1984 Volkswagen Scirocco L4-1781cc 1.8L SOHC
Vehicle > Lighting and Horns > Backup Lamp > Technical Service Bulletins
UPSHIFT/BACK-UP LIGHT SWITCH - CONNECTOR CHANGE

90vw04
Subject: Transmission upshift/back-up light switch - Wiring change to connector when replacing switch

Model(s): Rabbit, Rabbit Convertible, Jetta, Scirocco Through m.y. 1984
Group: 97

Number: 90-01

Rabbit - Through m.y. 1984

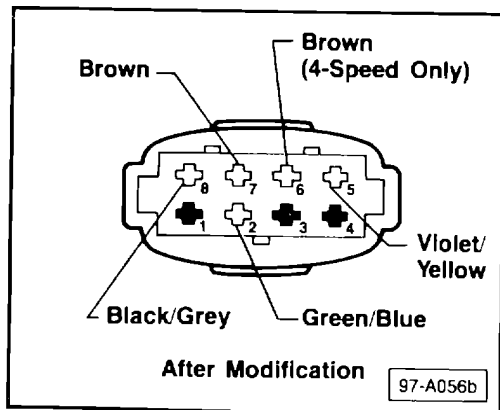
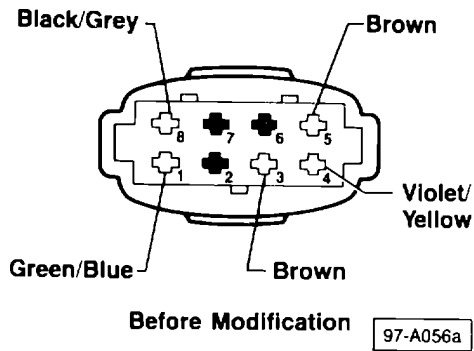
The original equipment transmission upshift/ back-up light switch Part No. 171 919 823J has been superceded by a new switch Part No. 191 919 823.

The wiring of the switch connector must be changed after installing a new switch.

- ^ move Green/Blue wire from terminal 1 to terminal 2
- ^ move Brown wire from terminal 3 to terminal 7

On 4-speed transmissions, ^ move Brown wire from terminal 5 to terminal 6

On 5-speed transmissions, ^ remove Brown wire from terminal 5 and tape to wiring harness

Rabbit Convertible, Jetta, Scirocco

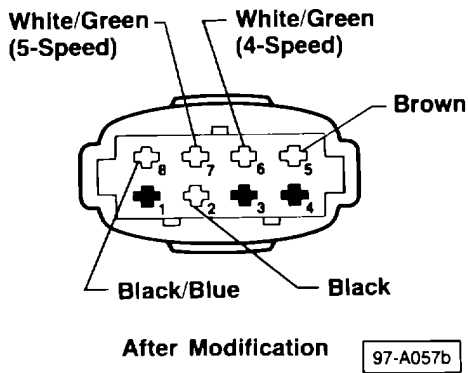
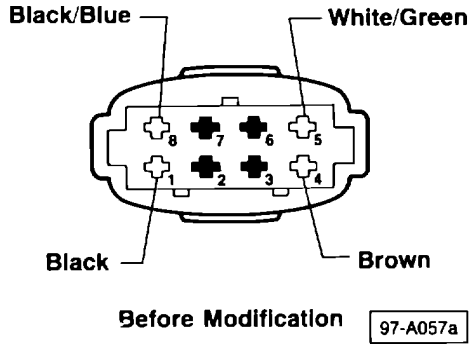
^ move Violet/Yellow wire from terminal 4 to terminal 5 (on both 4-speed and 5-speed transmissions)

^ move Black wire from terminal 1 to terminal 2

On 4-speed transmissions, ^ move White/Green wire from terminal 5 to terminal 6

On 5-speed transmissions, ^ move White/Green wire from terminal 5 to terminal 7

^ move Brown wire from terminal 4 to terminal 5 (on both 4-speed and 5-speed transmissions)
